Architectural Design Review Board  
August 1, 2023 @ 4:00 p.m.  
Council Chambers  
First Floor, 345 High Street  
Hamilton, Ohio 45011

**To:** Architectural Design Review Board  
**From:** Dani Baxter  
**Subject:** New Business - AGENDA ITEM #1  
690 Marcia Ave – Garage Door Replacement  
Mallory Greenham, Applicant  
Meeting Date: August 1, 2023  
Received Application: July 6, 2023  
**Impacts:** Ohio Historic Inventory

**Exhibit D – Rendering & Material Specs**

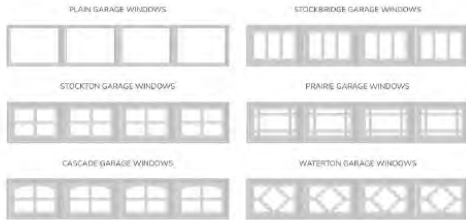
- The current wood garage door is deteriorated and cracked due to water damage and poses a safety concern.
- The existing garage door is not insulated and is mechanically inoperable.
- Applicant proposes the stockbridge window inserts as they best mirror the historic steel casement windows on the primary structure.
- Applicant is proposing the sandstone color to match the stucco around the bottom of the primary structure and complement the surrounding brick.

Site Photos July 2023

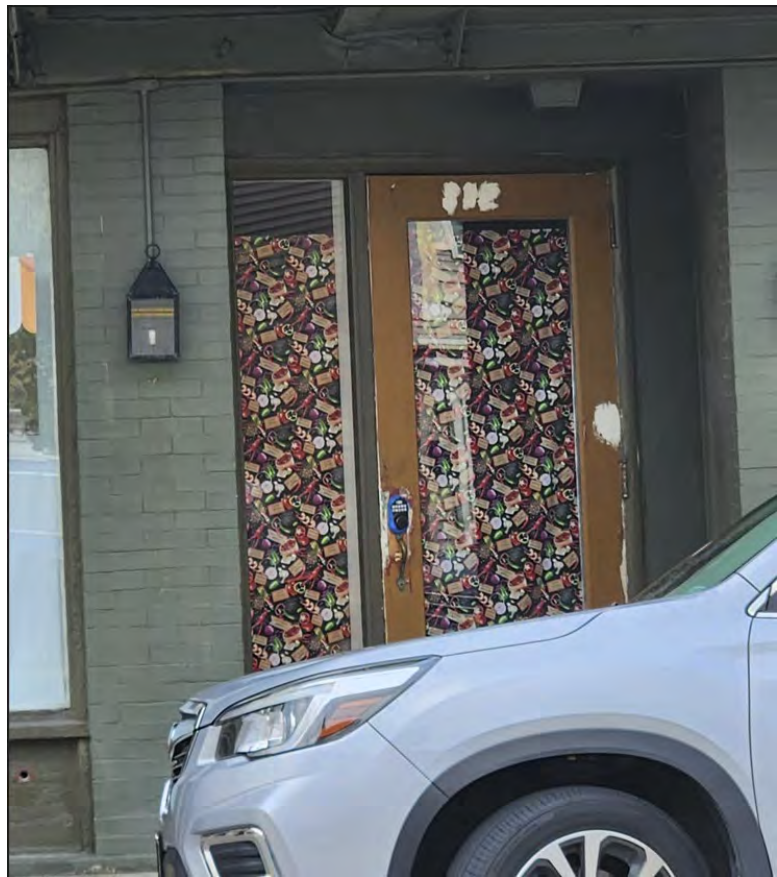
- No advertising is proposed for the awning.
- While there is currently no awning installed at this location Google Street View images show that there was an awning at this location from October 2007 through July 2012.
- Planning Department staff believe the proposed awning will complement the previously administratively approved trim and accent paint colors. The main body color (Garden Gate) is not being repainted.
- Applicant will need to apply for an awning permit with the City of Hamilton Building Department before installation.

May 3, 2023- Site Inspection Photos

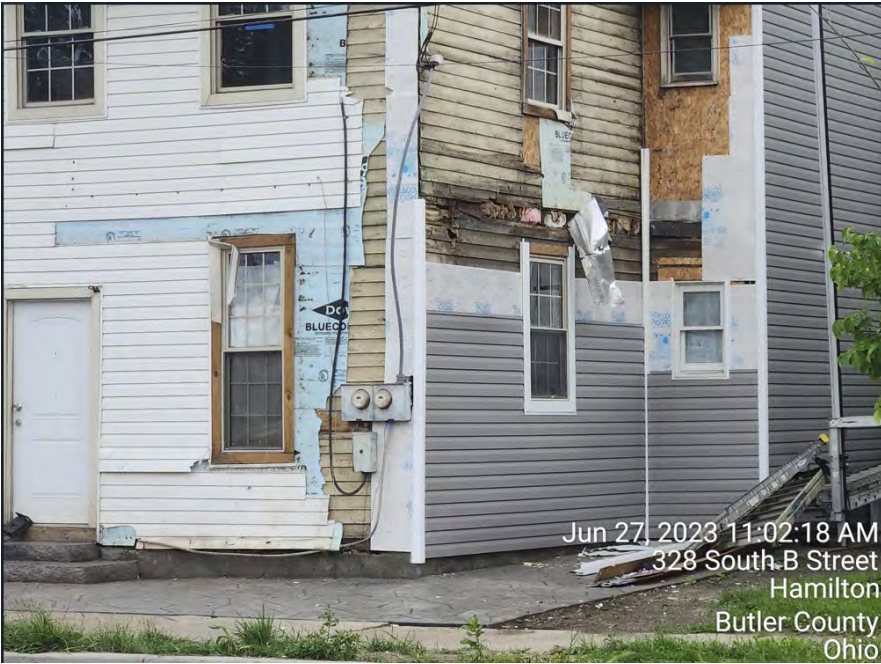
- While on site Planning Department staff noticed damage to the existing wood siding along the southwest side of the home where the porch structure was removed. The northeast (side), southeast (rear), and some of the southwest (side) facades were already covered with the new vinyl material so additional damage could not be photographed. Staff believed that the wood siding on the front of the building, which was partially exposed, appeared to be in good condition.
